From: Miles
Sent: 23/09/2024 11:54:40 AM
To: Council Northernbeaches Mailbox
Subject: TRIMMED: Objection to 14 Bassett Street Mona Vale
Attachments: 2nd Objection to DA 14 Bassett St Goodman & Brosnan (1).docx;

Re: Objection to Development Application Number: [DA2024/0534](#) 14 Bassett Street, Mona Vale.

a) Habitable rooms are overlooked

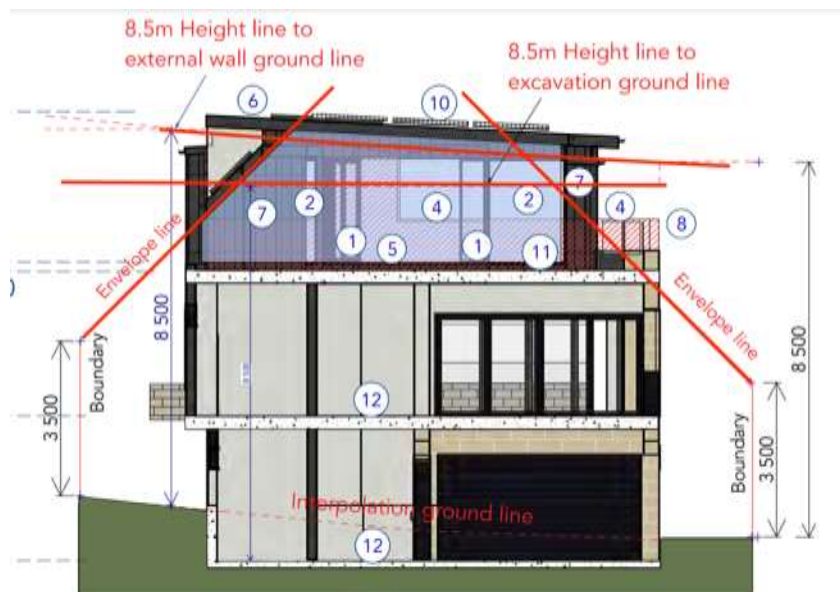
The new terrace and living area would have views into our three bedrooms and living room. This photo suggests that the addition of a 600mm awning will be inadequate. There is no good reason for this development to so completely ignore the building envelope. These awnings increase the bulk of the building, and are a clumsy attempt to retrofit a poor plan when confronted with the reality of the impact on neighbours.
